FIRE SAFETY INSPECTION REPORT

Factory Name: MNR Design Ltd.

Inspected By: Mahfuza Khanom & Md. Tarif Raihan
Date: 20th February, 2019

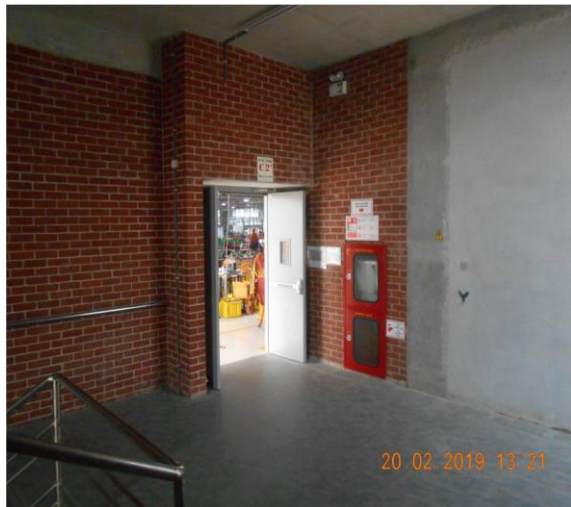
12	Egress	<p>Dining located at 4th floor having more than 500 fixed seats with only 2 exit stair. Location: Main Building</p>	<p>Reduce occupant load to not more than available exit capacity as per Accord 6.6.3.</p>	<p>Immediate</p>
